RE: *Application of Limestone Water Utility Operating Company, LLC, to Expand its Certificate of Convenience and Necessity to Serve the Campbell Hollow Subdivision, TPUC Docket No. 25-00057*

We are in receipt of your inquiry and requests regarding the minimum filing requirements in the above-referenced docket. Please find the responses from Limestone Water Utility Operating Company, LLC (“Limestone”) below.

PROPOSED SERVICE AREA MAP CAMPBELL HOLLOW (WASTEWATER) SEVIER COUNTY, TN

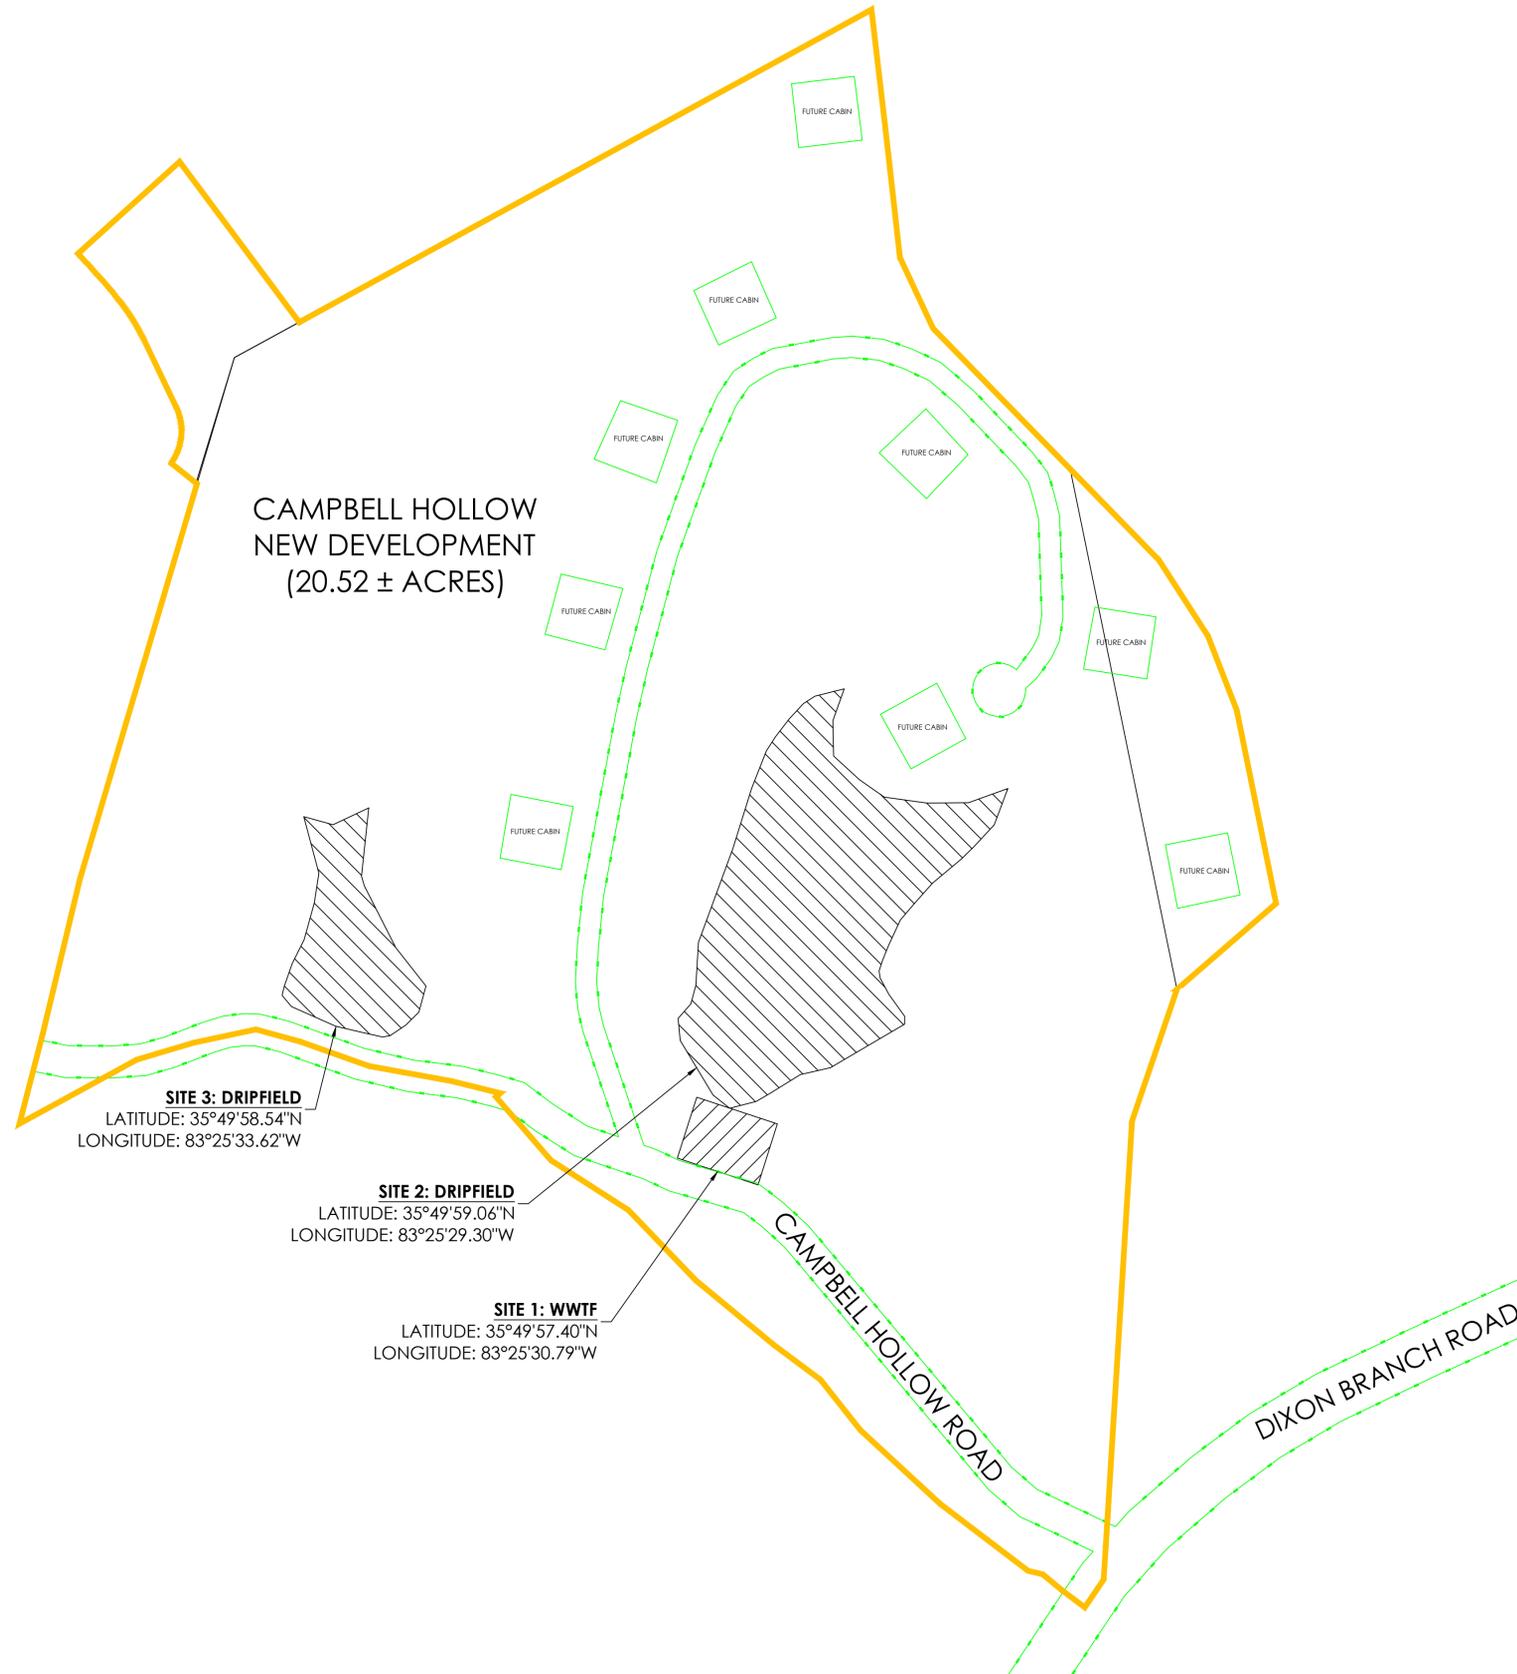
- 3. Rule 1220-04-13-.17(2)(a)7(ii-iii).** The rule asks for names of surrounding streets and roads; and the rule asks for a map to show access roads and names of access roads (if available) and the other utilities necessary to provide wastewater service. Exhibit 1 is a map, but it does not include all surrounding road names and properties. File an exhibit to show these requirements in the Docket.

- 4. Rule 1220-04-13-.17(2)(a)7(iv).** The rule asks for a map of all residences and habitable structures served by the wastewater system. Exhibit 1 is a map, but it does not include a map of the residences and habitable structures. File a map that shows the details of this requirement in the docket.

Response: Please see Attachment “DR 2 – Campbell Hollow Map.”

Response: Please see Attachment “DR 2 – Campbell Hollow Map.”
